## **1. FALLOWFIELD TRANSIT TERMINAL AND PARK AND RIDE LOT - FUNCTIONAL DESIGN**

Our File/N/Réf.	48-95-0011
DATE	8 November 1999
TO/DEST.	Co-ordinator Transportation Committee
FROM/EXP.	Planning and Development Approvals Commissioner
SUBJECT/OBJET	<b>FALLOWFIELD TRANSIT TERMINAL AND PARK AND RIDE LOT - FUNCTIONAL DESIGN</b>

## **Fallowfield Park and Ride Lot - Questions and Answers**

**FALLOWFIELD TRANSIT TERMINAL AND PARK & RIDE LOT  
ULTIMATE DESIGN**  
(Following construction of the Southwest Transitway Extension)

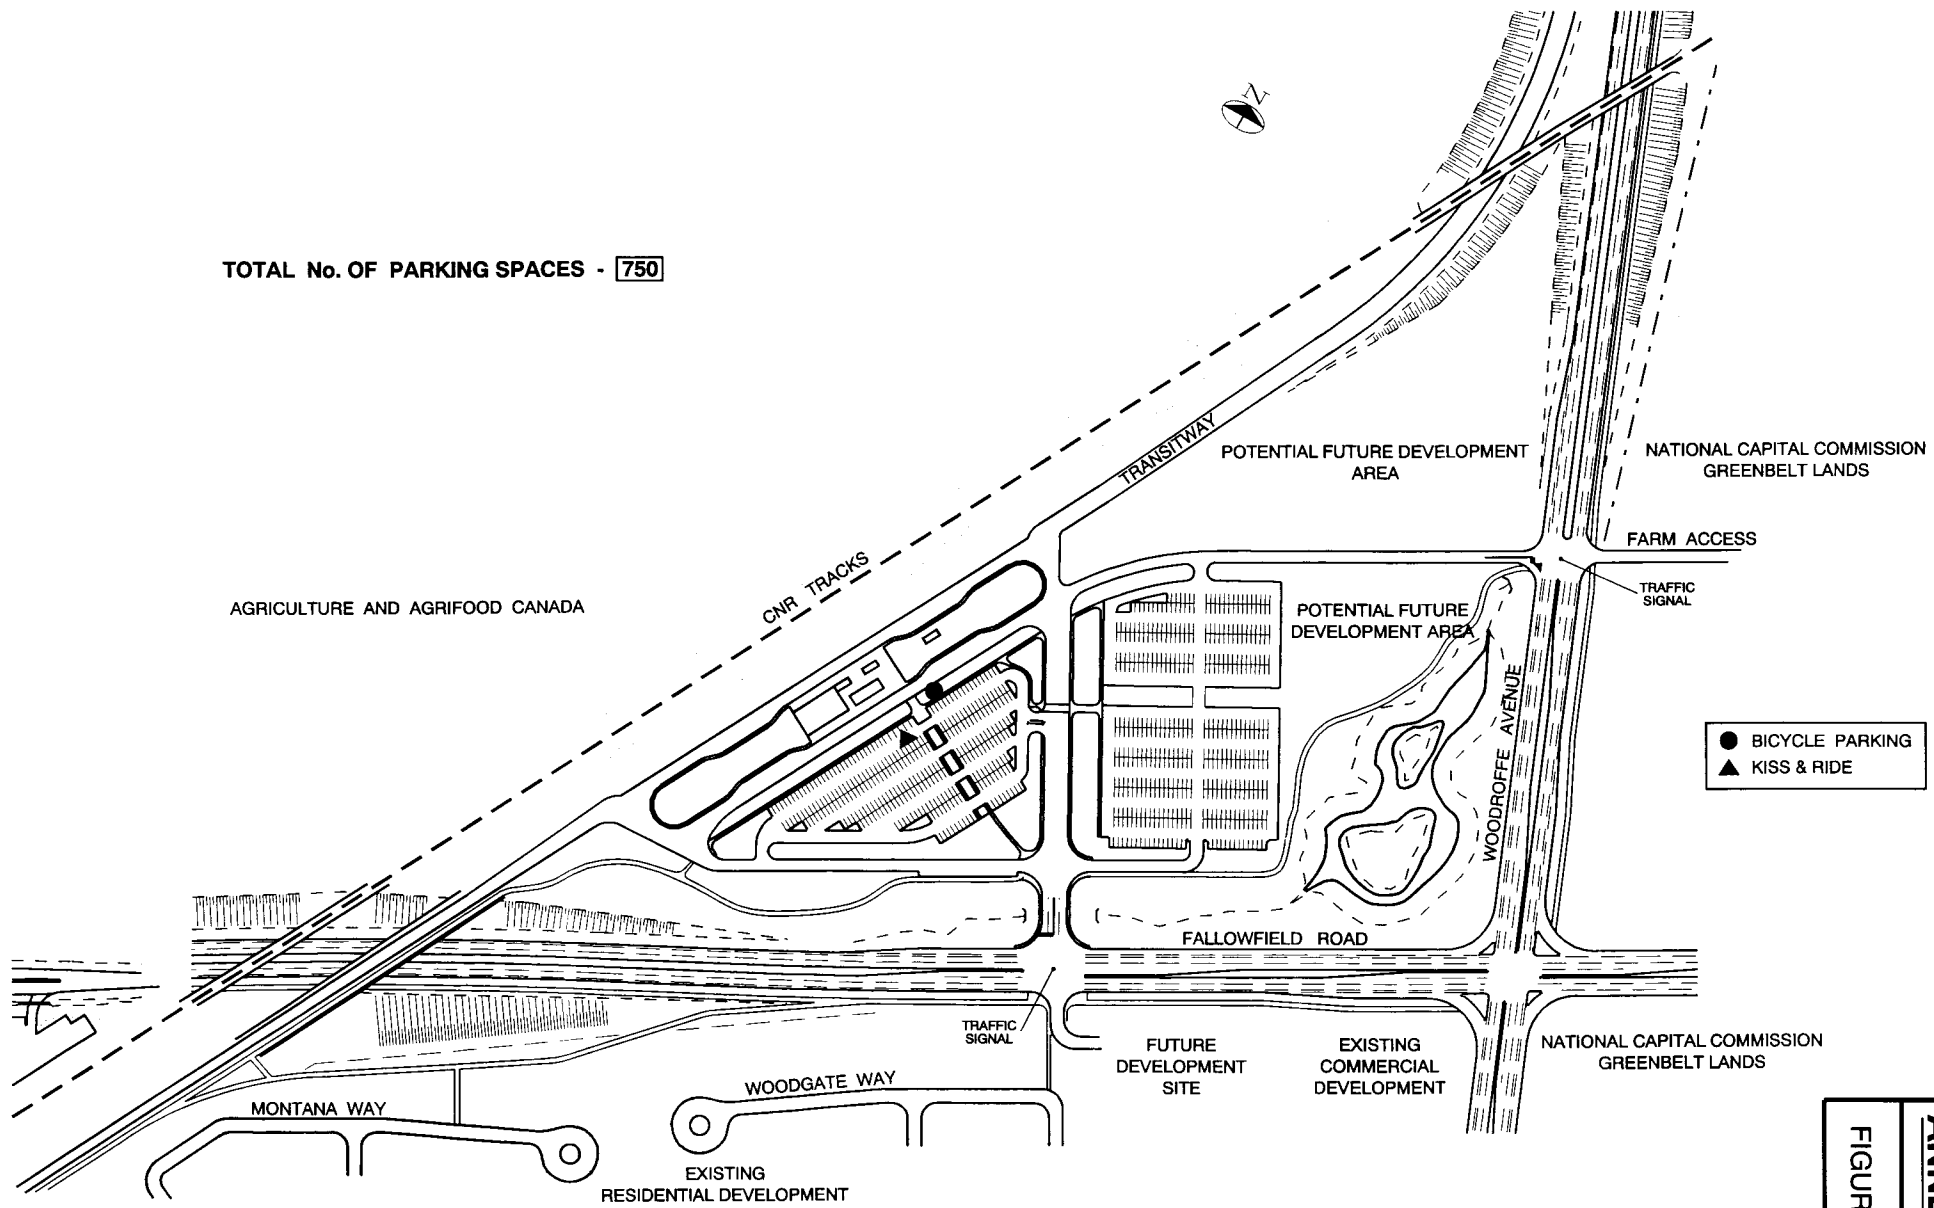
2. Comment: The intersection design for the Woodroffe/Fallowfield intersection is "unfriendly" for cyclists.

3. Comment: The Region should implement a bike locker pilot project at the Fallowfield Park and Ride lot.

**32. *Can the triangle parking lot be moved further upward towards Woodroffe Avenue since at this time further expansion of the facility is yet to be deemed necessary? Would it be possible to change the proposed staging so that the parking area located across for Woodgate Way is implemented last?***

Response: The design of the Woodroffe/Fallowfield intersection is beyond the scope of the Park and Ride Project. However, given the intersection's proximity to the site, a conceptual layout of the intersection was shown on the drawings for completeness only. This concept was taken from the 1997 Fallowfield Road - Cedarview to Woodroffe EA Study.

Response: The design identifies a bicycle parking area adjacent to the westerly transit platform which does not preclude the installation of bike lockers. Staff recommend that bike racks be installed during the initial phase. As the Park and Ride facility is expanded, the number and type (bike racks, sheltered bike racks, or bike lockers) of bike parking facilities will be re-evaluated in consultation with RCAG and OC Transpo.

proposed design is a careful balance of all these components. The "triangle parking area" has been located to service both the interim and future transit stations. Moving the parking area to the north would remove it from the station area and thereby increase the walking distance for the users.
